TO: JPL Development LLC
FROM: Peter Vickerman, Planning Manager
DATE: May 3, 2022
SUBJECT: Edison at Maple Grove Apartments

TO: Peter Vickerman
FROM: Brandon Stenglein
DATE: 4/25/2022
PROJECT NAME: Edison Apartments
LOCATION Garland Lane North and County Road 30
PID 08-119-22-24-0003
SUBMITTAL Development Stage

RE: Edison Apartment Site Plan Review

SUBJECT: Edison Apartments – Final Plat

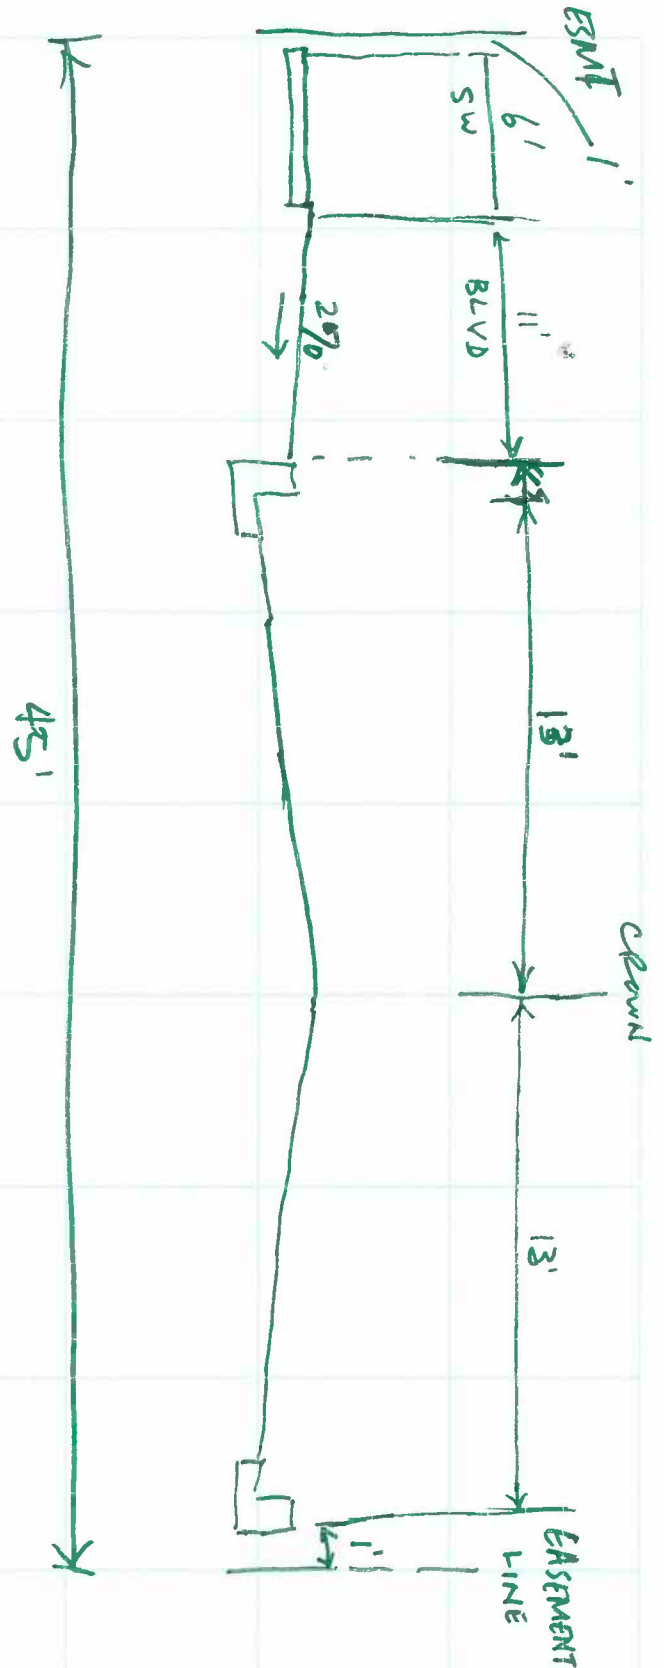
Status
a. Tricare 4th public improvements are ongoing. Roads to be built in spring of 2022	Informational
b. Future 610 pond may be available for additional treatment	Informational
c. More information is needed for typical section of main access road, the easement dimensions, boulevard dimensions, and boulevard grades. See attached sketch for requirements.	Unresolved - Resubmit
